JLRTB02074NAS1  
**TECHNICAL BULLETIN**  
01 MAR 2021

Front Bumper Towing Eye Cover - Modification

MODEL:	MODEL YEAR:	VIN:	ASSEMBLY PLANT:
F-PACE (X761)	2021	663013-670434	Solihull

E279997

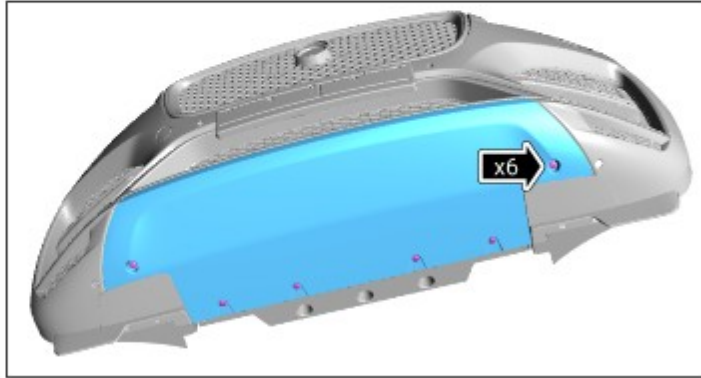
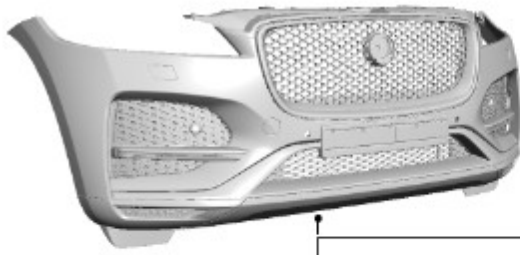
Remove the front towing eye cover.

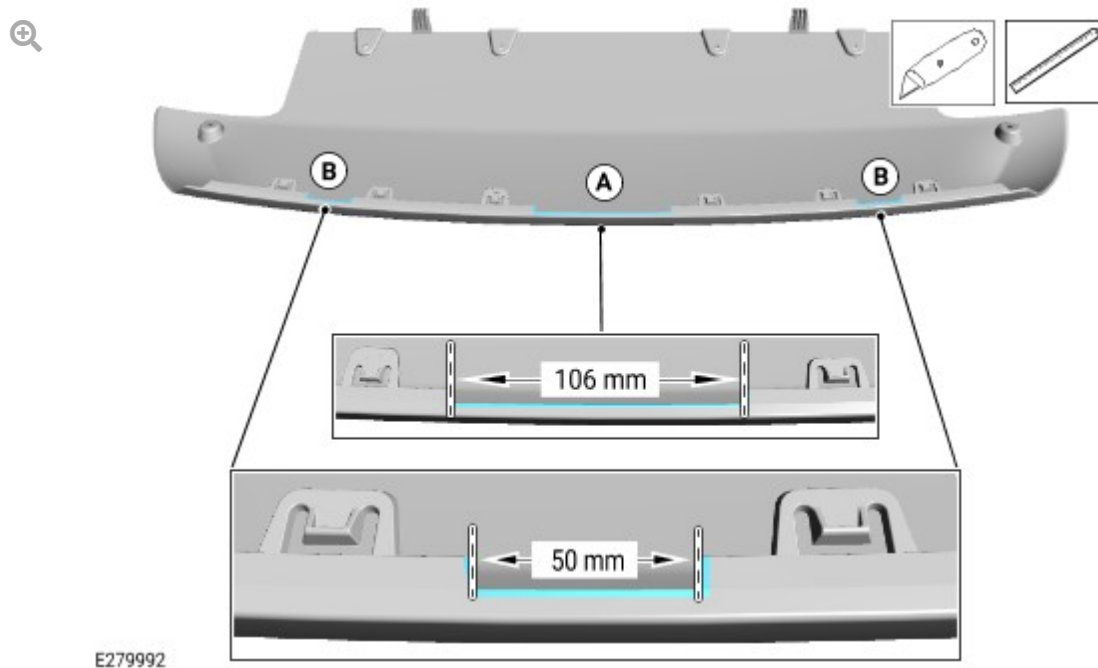
Do NOT increase the depth of the slotted area.

Using a suitable tool, modify the front towing eye cover, as shown in the illustration. Make sure an equal amount of material is removed from each side of the slotted area, which will allow the slotted area to remain central, between the fixing tabs.

- Slotted area marked 'A' - 106 mm wide.
- Slotted areas marked 'B' - 50 mm wide.
